NAME	EFD-4651-1 CAP	MATERIAL	PET-FR530	SCALE	1:1	ANGLE	±1°
DRAWING NO.	HX 4602B	PIN MATERIAL		UNIT	m/m	REV.	01
TOLERANCE OF PIN DIA ±0.05		PIN TENSION	LOAD	kg MIN		UL REC.:	94V0
TOLERANCE:							
DESIGN & DRAWN BY	LIN HUI JING	CHECKED & APPROVED BY	LIN GUO PING	DATE:	AUG 12 2010

东莞市华欣塑胶制品有限公司
 DONGGUAN HEALY PLASTIC MANUFACTURING PRODUCTS CO., LTD.
 TEL: 0769-86388188 FAX: 0769-86388111
 E-Mail: hxbobbin@vip.163.com

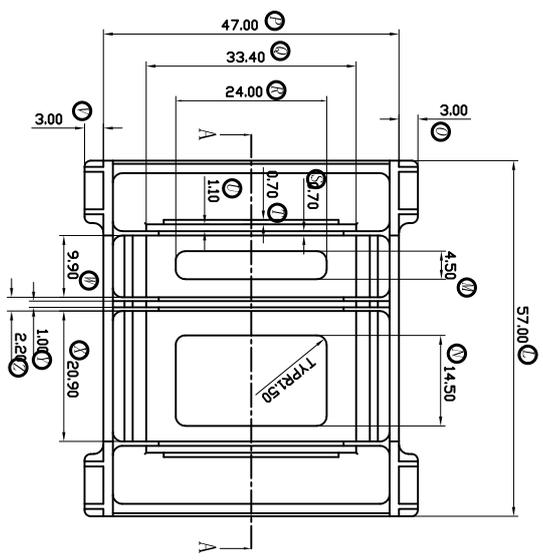
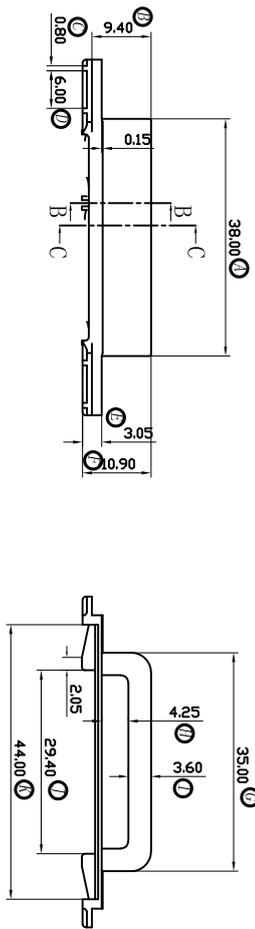
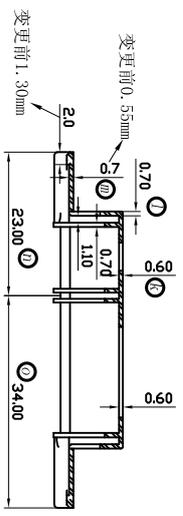
记号	日期	修改记录
1	2010/12/16	1. m尺寸由0.55mm改为0.70mm。 2. 加强筋宽度由1.30mm改为2.00mm。
